Product Change Notification

Change Notification #: 838449-00

Change Title: Intel® Wireless-AC 9260, 2230, 2x2 AC+BT,

Regulatory label updates

9260.NGWG Product Label - Before

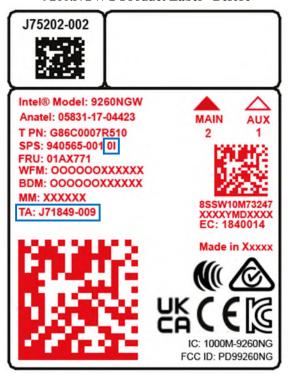
- 1. Update Japan Giteki MIC logo on the Disti label.
- 2. Update Pakistan PTA certification marking on the Disti label.
- 3. Update Oman TRA product marking on the Disti label.
- 4. Update Singapore IMDA's compliance marking box on the Disti label.
- 5. The Intel tracking revision will be changed on the following products.
